State of New Mexico
Energy, Minerals and Natural Resources

OIL CONSERVATION DIVISION
1220 South St. Francis Dr.
Santa Fe, NM 87505

| SUNDRY NOTICES AND REPORTS ON WELLS (DO NOT USE THIS FORM FOR PROPOSALS TO DRILL OR TO DEEPEN OR PLUG BACK TO A DIFFERENT RESERVOIR. USE "APPLICATION FOR PERMIT" (FORM C-101) FOR SUCH PROPOSALS.) | | WELL API NO. 30-005-61336 |

LEASE/WELL: COLLINS SW STATE #1
LOCATION 660' FNL & 660' FWL
D-SEC 25-T04S-R24E
CO/ST: CHAVES COUNTY, NEW MEXICO
FIELD: PECOS SLOPE; ABO
API NO. 30-005-61336

AFTER P&A

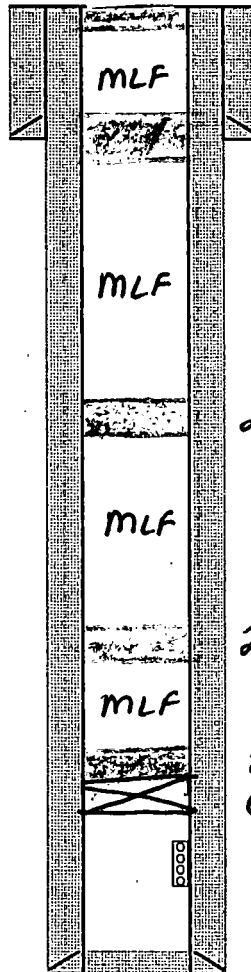
1. Notify OCD 24 hrs prior to MIRU to P&A.
2. Set CIBP @ 3597' tag w/tbg circ hole w/MLF test csg.
3. Spot 25 sx's cmt @ 3597'-3497' WOC & TAG ~~if csg don't test~~.
4. Spot 25 sx's cmt @ 3000'-2900'.
5. Spot 25 sx's cmt @ 1600'-1500' (GLORIETA).
6. Spot 75 sx's cmt @ 979'-550' WOC & TAG (8 5/8" SHOE, SAN ANDRES).
7. Spot 15 sx's cmt @ ~~30'~~ surf. 100' - surf
8. Cutoff wellhead and anchors, install dry hole marker & move off.

*See Attached COA's must be plugged by 3/13/20
I hereby certify that the information above is true and complete to the best of my knowledge and belief.
